Gilmerton Road, Edinburgh

Temporary Cycle Infrastructure

Road Safety Audit Stage 3

Overseeing Organisation Reference: RSA/20/050
AECOM Reference: RSA/323/S3-A

Problem: 4.1.3

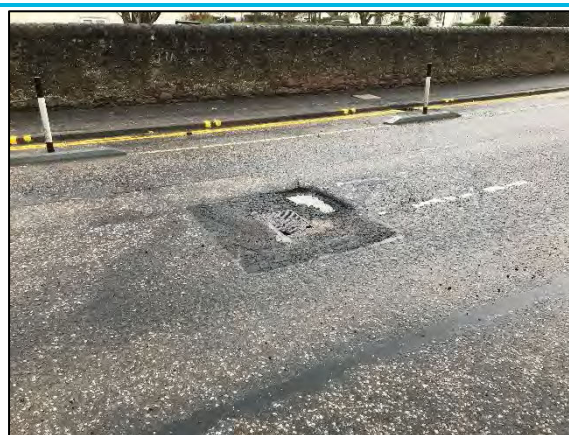
Adjacent to Inchpark Surgery, an area of uneven surfacing was observed in the centre of Gilmerton Road, as shown in the photograph above. The carriageway surface appears to have broken up around the ironwork, which itself was also damaged.

There is a risk that a driver / rider could lose control of their vehicle were they to travel over this area of surfacing, which could lead to the vehicle occupants / riders sustaining personal injuries. There is also a risk that a driver / rider could swerve to attempt to avoid this area, which could lead to them colliding with another road user.

It is recommended that the ironwork and the surface of the carriageway are appropriately repaired / made good.

Problem: 4.4.2

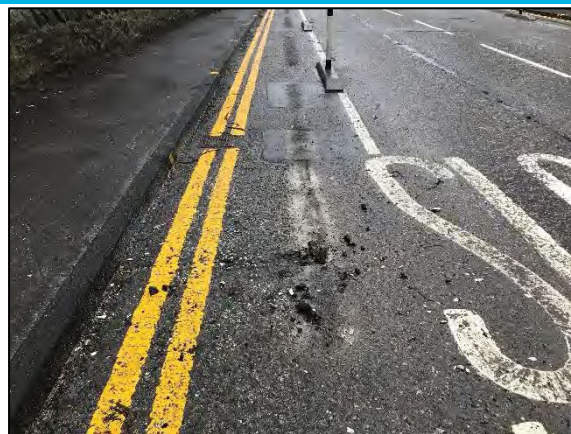
As shown in the photograph above, the surfacing in the cycle lane at this location was found to be very uneven, with part of the surface having come loose and with a small pothole in the surface.

There is a risk that a cyclist could travel over this area of surfacing, lose control of their bicycle and sustain a personal injury. There is also a risk that a cyclist could swerve to avoid the pothole / debris and collide with another road user, a kerb or an item of street furniture.

It is recommended that the surface of the cycle lane is appropriately repaired / made good.

Problem Location Plan 1

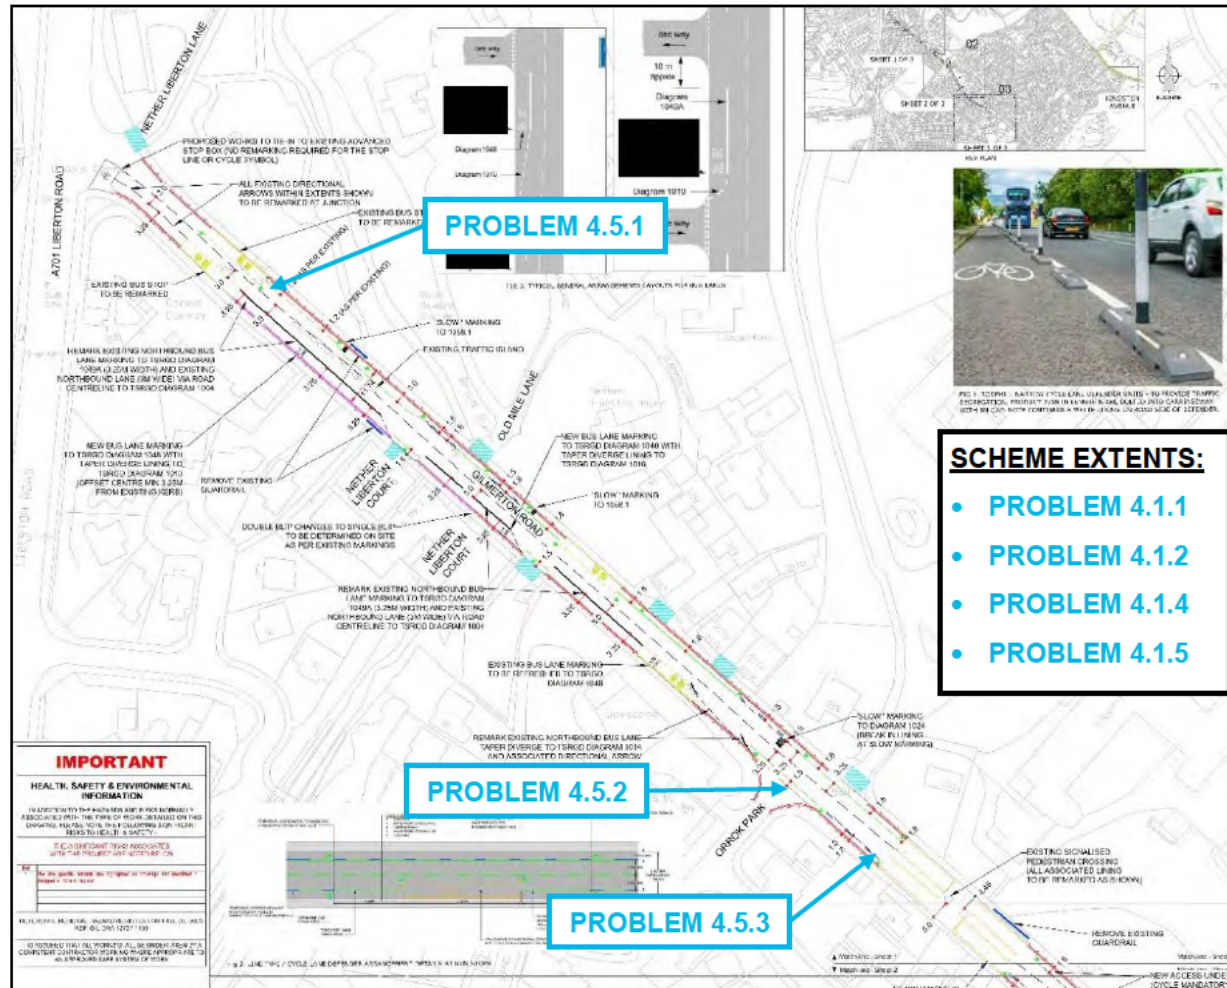
- 2.14** Where applicable, the locations of problems are shown in conjunction with the scheme proposals in Appendix B where the reference numbers relate to the problems identified in this report.
